PTK - A1 - 00 - D - A - 1001 P06

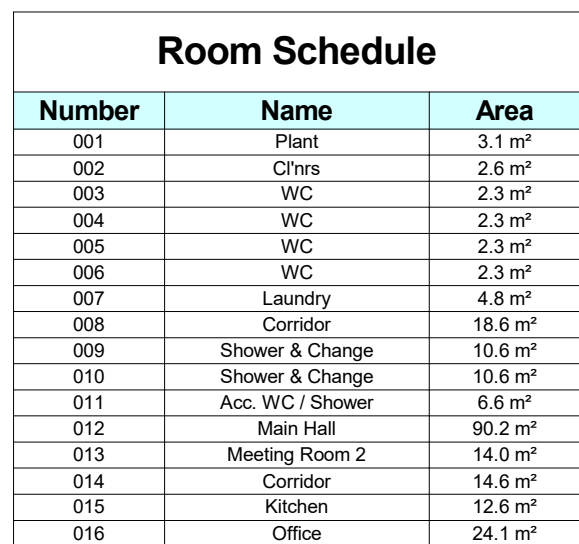
| P06 | 22/02/26 | Timber cladding extent reduced to Elevations B and C, RWP relocated (between Grids 9/10) | MC | SPM |
